Technical Service Bulletin (TSB)
Wrong Instrument Panel Cluster (IPC) Configuration

REFERENCE:	TSB: 08-328-26 REV. A GROUP: 08 - Electrical	Date:	September 5, 2026	REVISION:	08-328-26
VEHICLES AFFECTED:	2026 (DT) RAM 1500 Pickup This bulletin applies to vehicles built on or after September 24, 2025 (MDH 0924XX) and on or before September 25, 2025 (MDH 0925XX) equipped with a Cluster 7.0" TFT Color Display (Sales Code JAL) or a Cluster 3.5" TFT Color Display (Sales Code JAK).			MARKET APPLICABILITY: ☒ NA☐ MEA ☐ SA☐ IAP ☐ EE☐ CH NOTE: This bulletin applies to North America markets.	
CUSTOMER SYMPTOM:	Customers may comment on one or more the following: - Oil pressure gauge and battery life gauges are blank or missing from the IPC Fig. 1. - The Trailer Brake radial slider movement will not move past one bar and is inaccurate Fig. 2. NOTE: The Trailer Brake percentage does display correctly.				
CAUSE:	IPC configuration

This bulletin supersedes Technical Service Bulletin (TSB) 08-328-26, date of issue September 03, 2026, which should be removed from your files. All revisions are highlighted with ****asterisks**** and include an updated LOP.

Fig. 1
Missing/Blank IPC Information

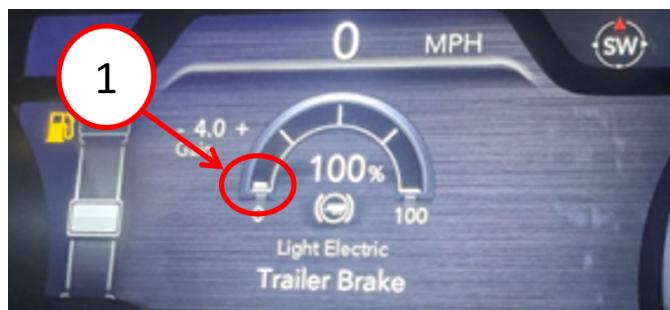
- 1 - Missing IPC Cluster Screen Option Selections
- 2 - Missing Oil Temperature Gauge
- 3 - Missing Battery Gauge

This bulletin involves performing a reconfigure and PROXI alignment on the IPC.

1. Using wiTECH, perform a Restore Vehicle Configuration by navigating to the Guided Diagnostics tab on the left hand menu, selecting Restore Vehicle Configuration, and then following the on-screen prompts.
2. Cycle the ignition Off, then to the Run position (**do not crank the engine**) and leave the ignition in the Run position for a minimum of 60 seconds.
3. Cycle the ignition to the to the Off position.
4. Cycle the ignition from Off then to the Run position (**do not crank the engine**).
5. Clear DTCs.
6. Perform a PROXI Configuration Alignment under the Guided Diagnostics menu.
7. Clear all DTCs.
